MI15-43

DATE : SEBTEMBER 2015	SECTION: 01 - Engine
SUBJECT : New Aramid Cord Alternators Drive Belts

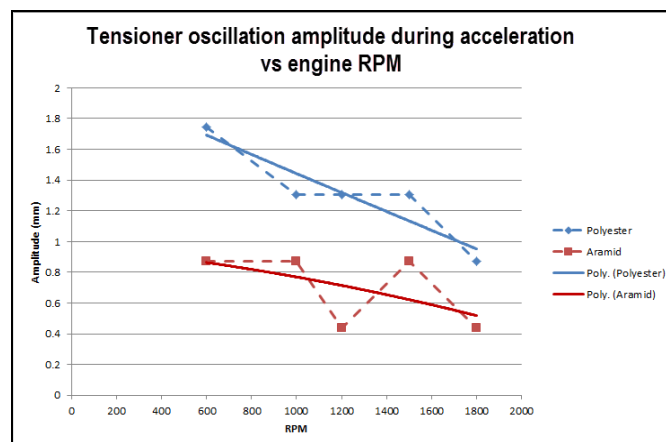
2011 and later PrevoSt vehicles equipped with Bosch HD10 alternators and using polyester cord alternator belt numbers:

- 5060129
- 5060115
- 5060130

New aramid cord poly-v belts are now available to replace the polyester cord alternator belts previously used on PrevoSt vehicles equipped with Bosch HD10 alternators.

- Significant tensioner oscillation reduction (up to 50% at some engine speeds) to *increase tensioners service life*.
- Stiffer construction allowing better belt length stability and minimal stretch to *extend belt life*.

SUPERSEDED PART #	DESCRIPTION	NEW PART #	DESCRIPTION
5060129	BELT, POLY V ORION QT	506020	BELT, POLY- V ARAMID CORD
5060115	BELT, POLY V ORION QT	506070	BELT, POLY- V ARAMID CORD
5060130	BELT, POLY V ORION QT+SD	506080	BELT, POLY-V SD ARAMID CORD
